MEMORANDUM

To: Ms. Rebecca Chu, EPA
From: Ryan Barth, P.E., Anchor QEA, LLC
Amy Essig Desai, Farallon Consulting, LLC
Cc: Gil Leon, Earle M. Jorgensen Company
Miles Dyer, Jorgensen Forge Corporation
Bill Joyce and Ian Sutton, Joyce Ziker
Parkinson, PLLC
Jeff Kray, Marten Law
Chris Schraff, Porter Wright
Ravi Sanga, EPA
Holly Arrigoni, EPA
Maureen Sanchez, Ecology
Will Ernst, The Boeing Company
Tom Colligan, Floyd Snider
Philip Spadaro, The Intelligence Group
Re: Jorgensen Forge Early Action Area Removal Action
Addendum to the Final Basis of Design Report
Administrative Order on Consent, EPA Docket No. CERCLA 10-2013-0032

REVISED BODR FIGURES

Figure 3
Soil Total PCB Concentrations
Basis of Design Report
Jorgensen Forge Early Action Area

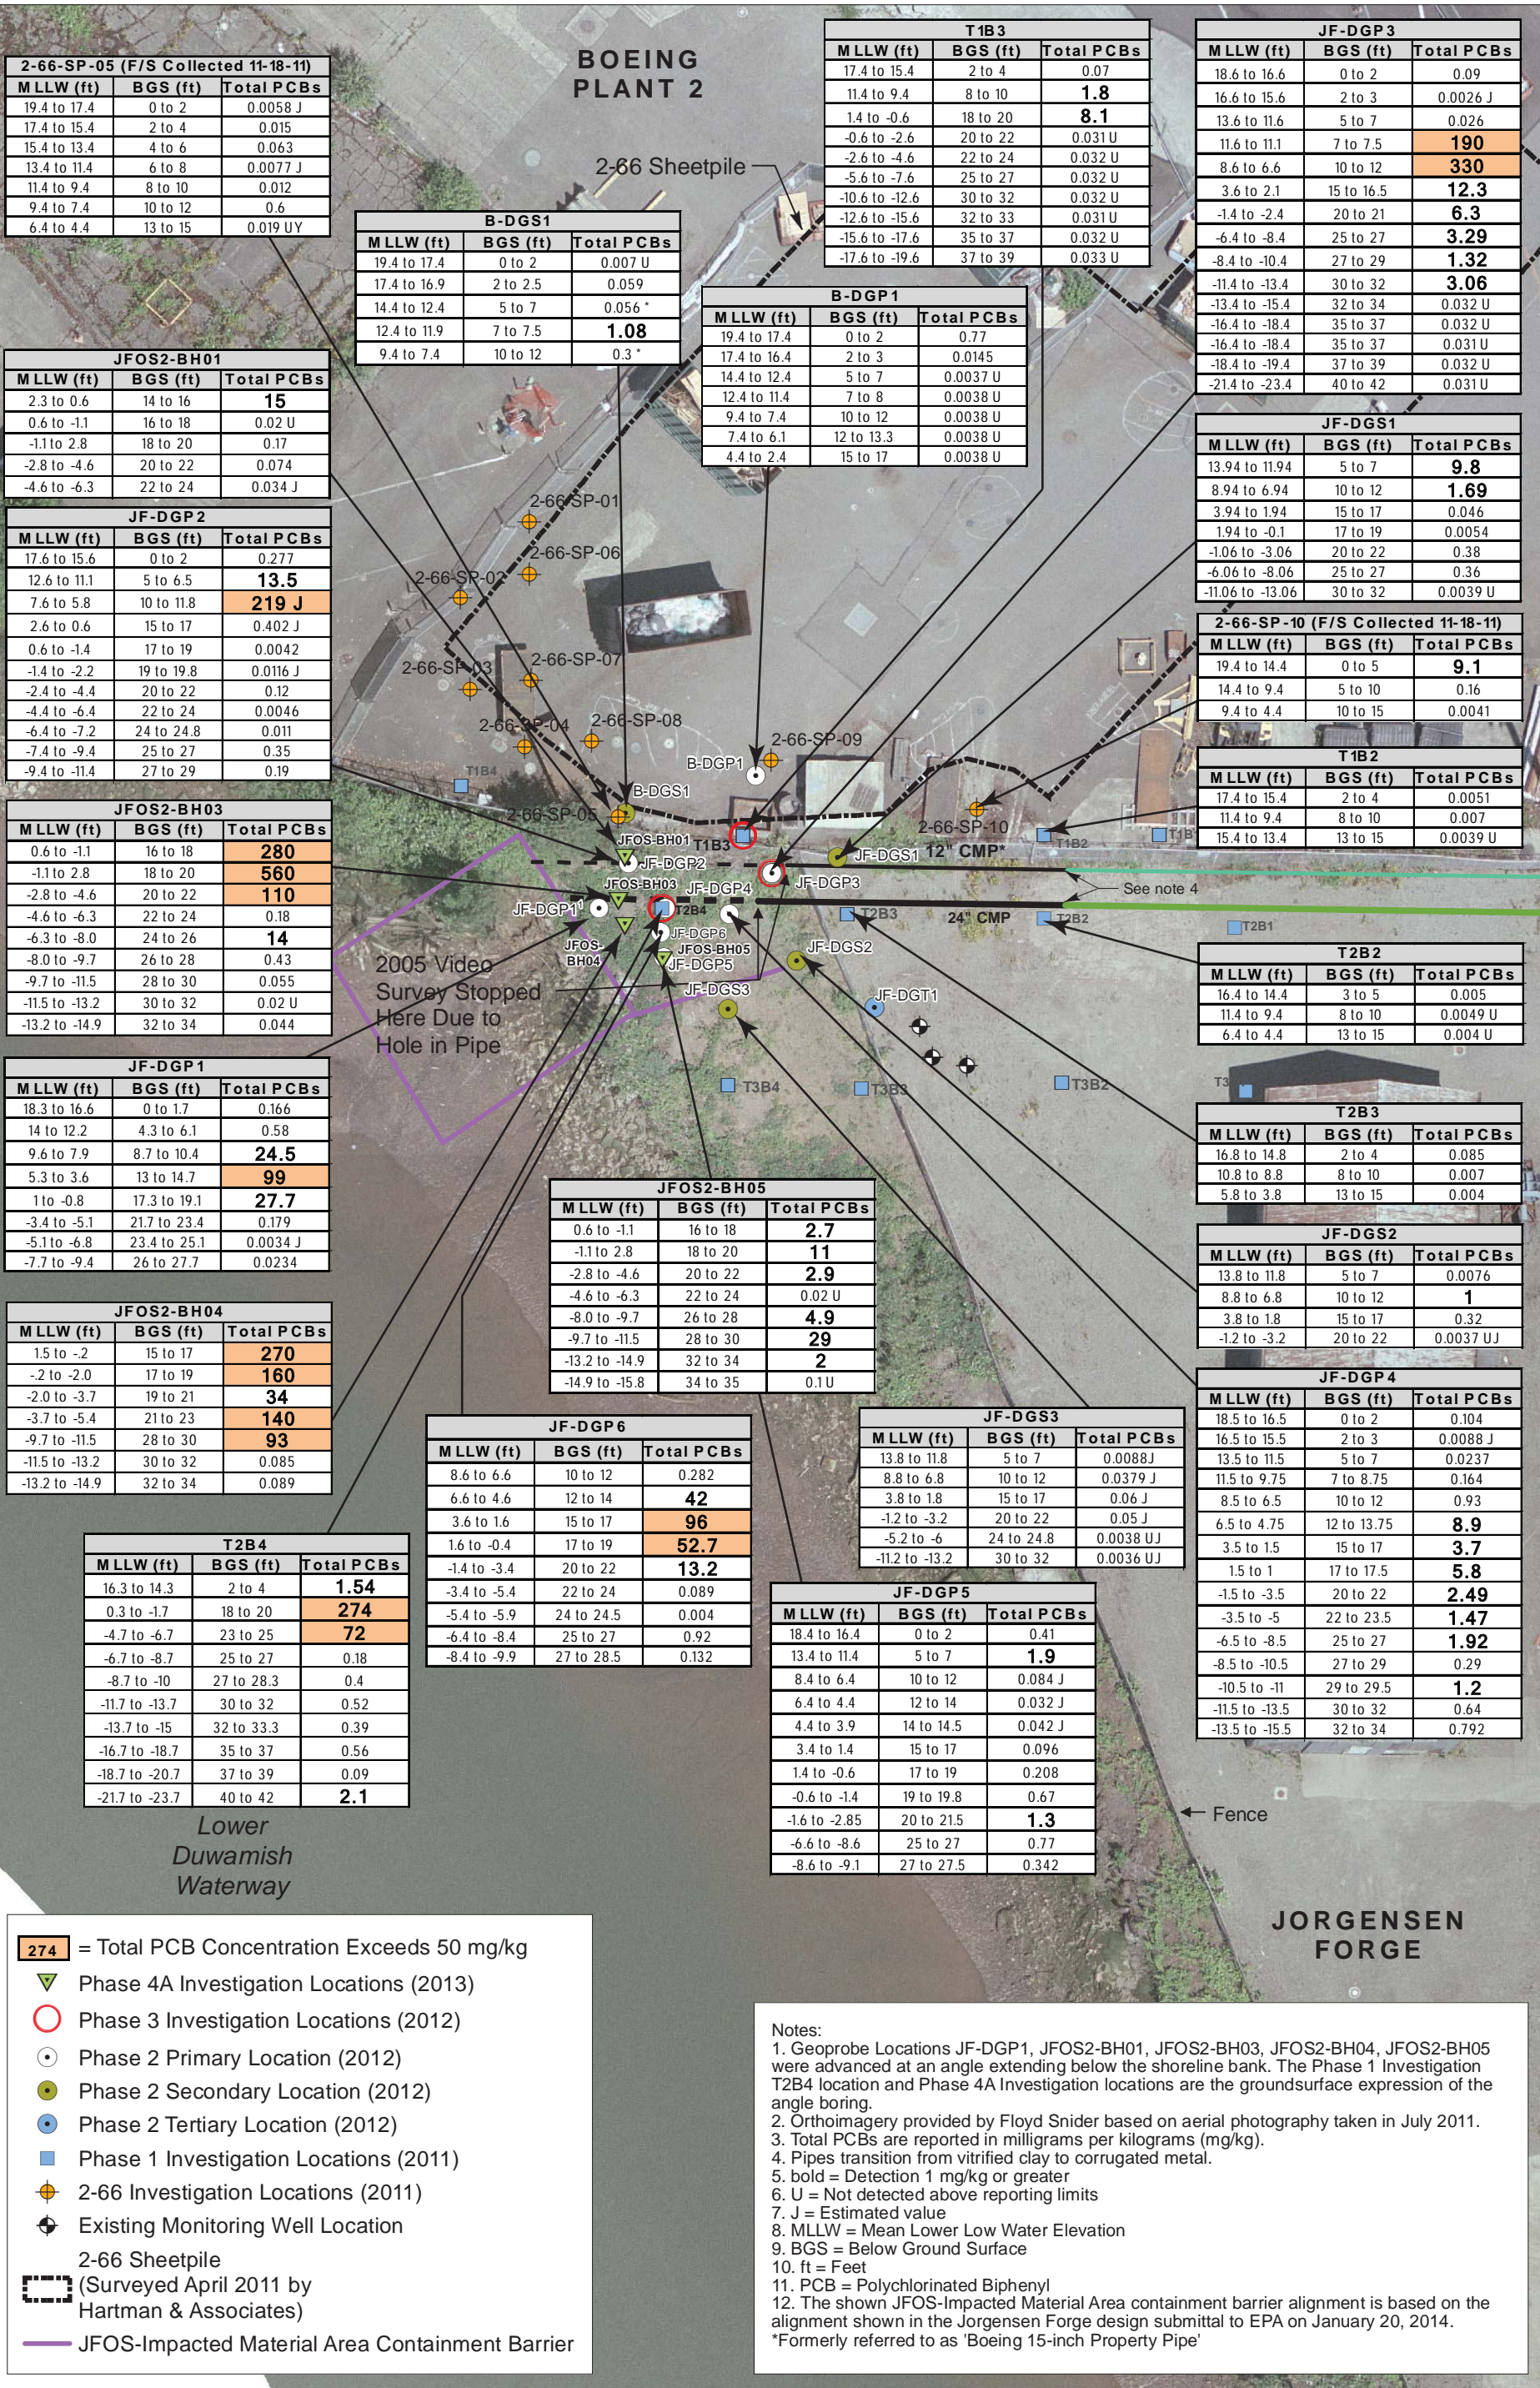
Attachment 1 presents revised BODR figures that incorporate the revised containment barrier alignment and the additional Geoprobe soil data. Attachment 2 presents the Phase 4a Geoprobe soil data.

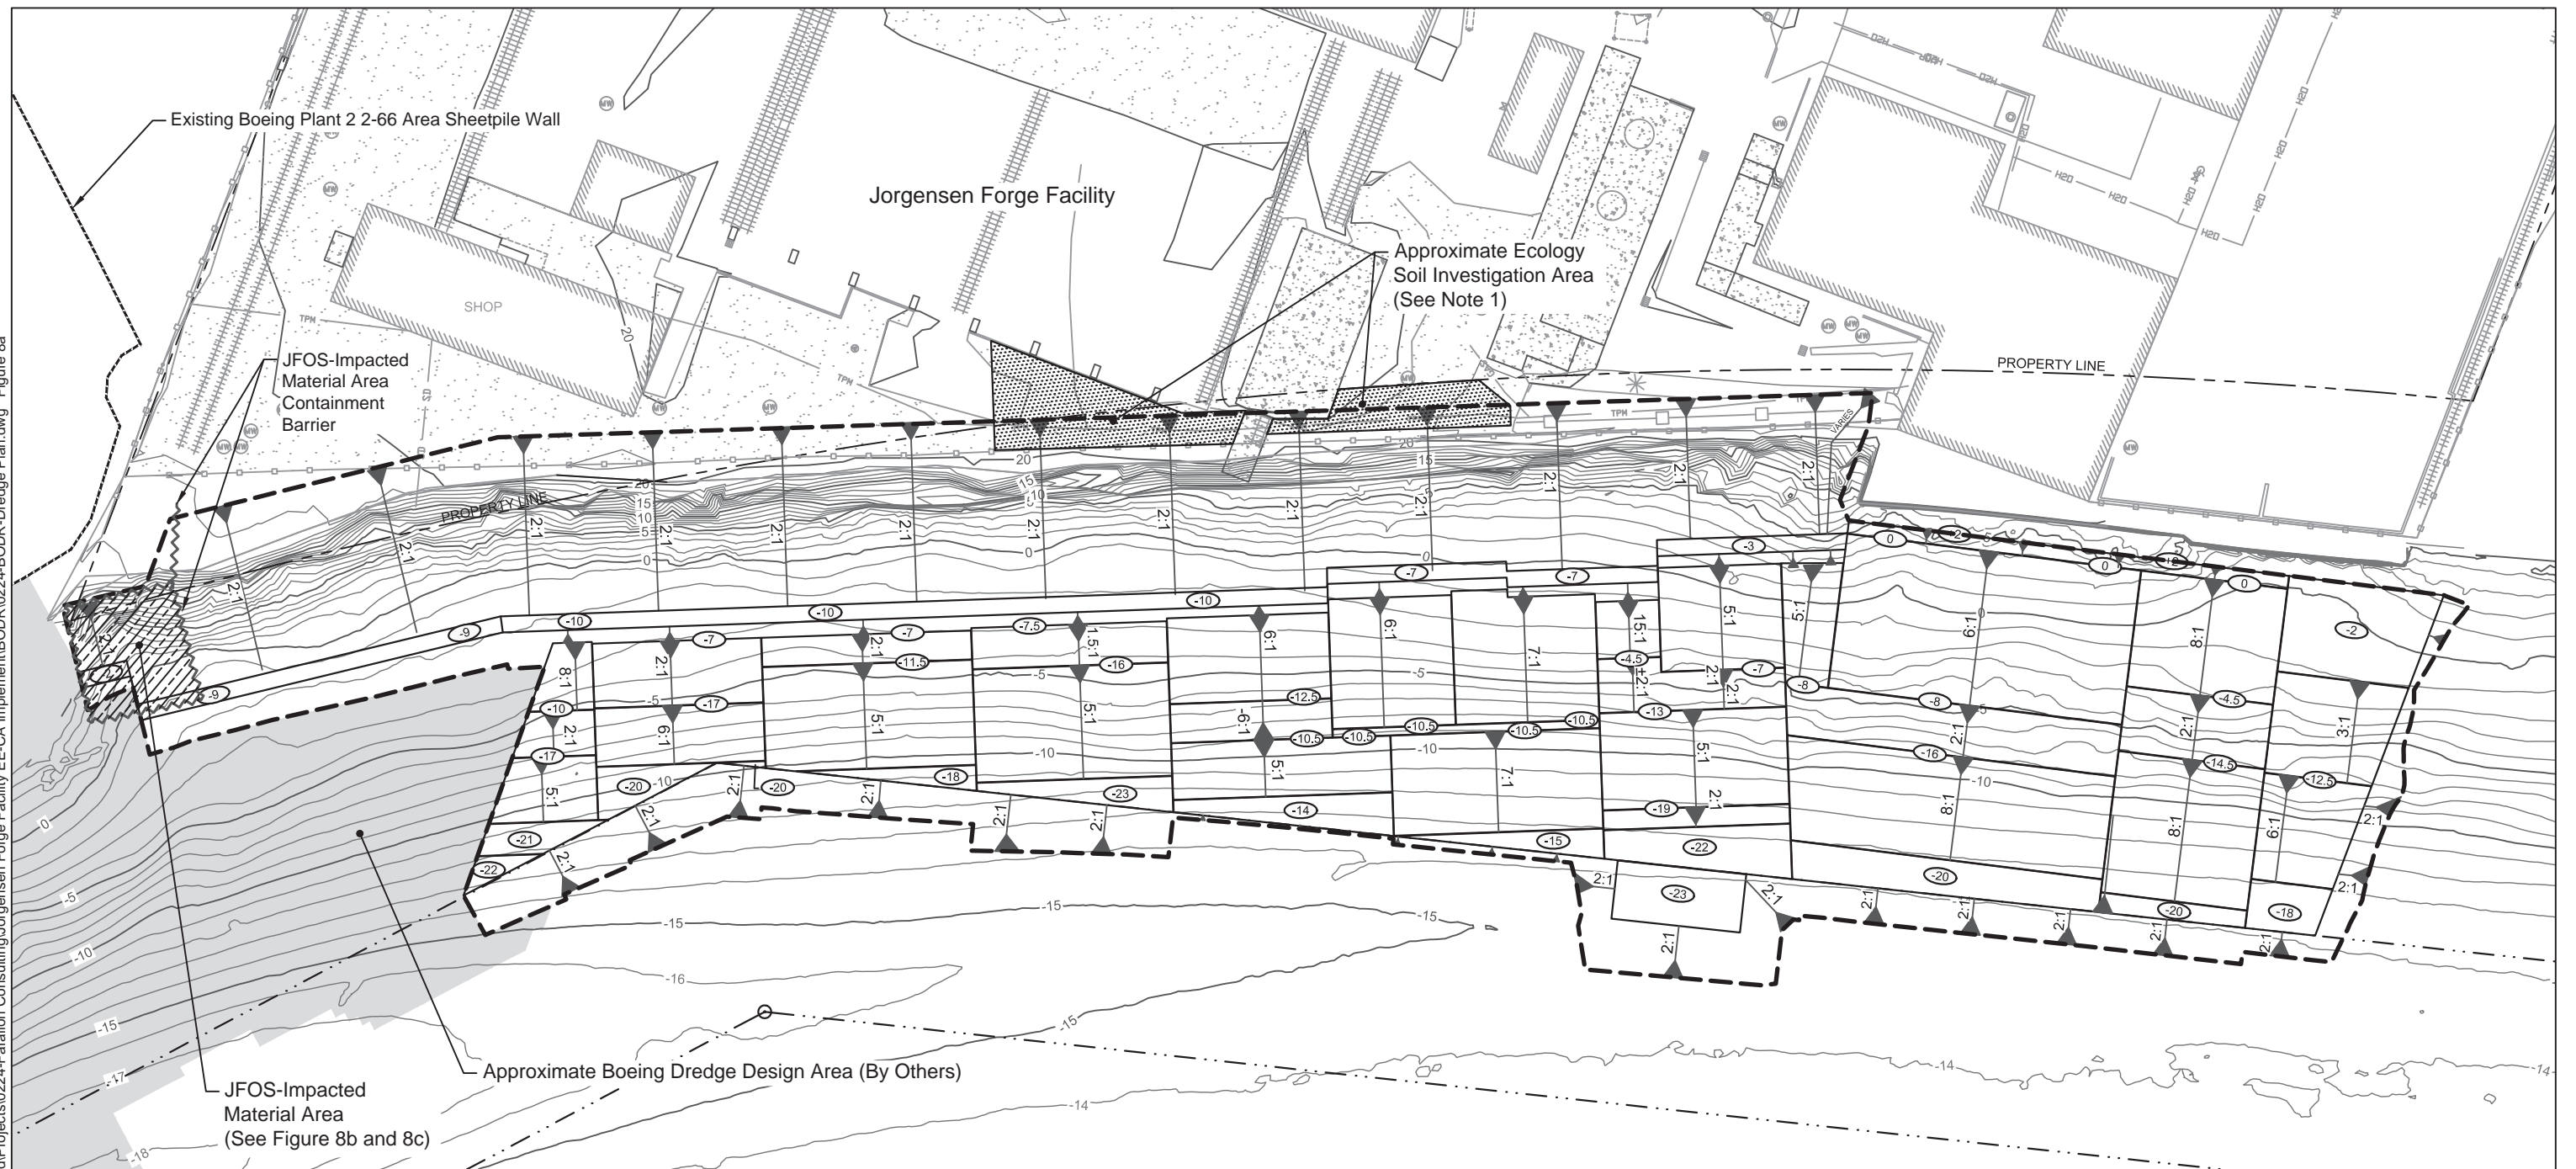
The abutting RAB and JFOS cleanup boundaries are presented on Figure 4 of Attachment 1. These boundaries are defined by the JFOS-Impacted Material Area containment barrier wall alignments identified in the Jorgensen Forge final design letter to EPA dated January 20, 2013 prepared by The Intelligence Group. The JFOS Second Modification to the AOC requires that Boeing/Jorgensen Forge construct these containment barrier wall(s) between the RAB and JFOS to facilitate removal of PCB-contaminated shoreline bank material due to releases from the property line storm pipes. EPA's letter to Boeing and Jorgensen Forge, dated January 23, 2014, approved the containment barrier wall alignments shown in Figure 4 of Attachment 1 and required the in-water portion of the alignment to be constructed by March 7, 2014, to eliminate the potential for delays to the EMJ Removal Action. If the in-water containment barrier (cofferdam) installation cannot be completed by March 7, 2014, then construction of a top-of-bank containment barrier alignment is required to commence by April 1, 2014.
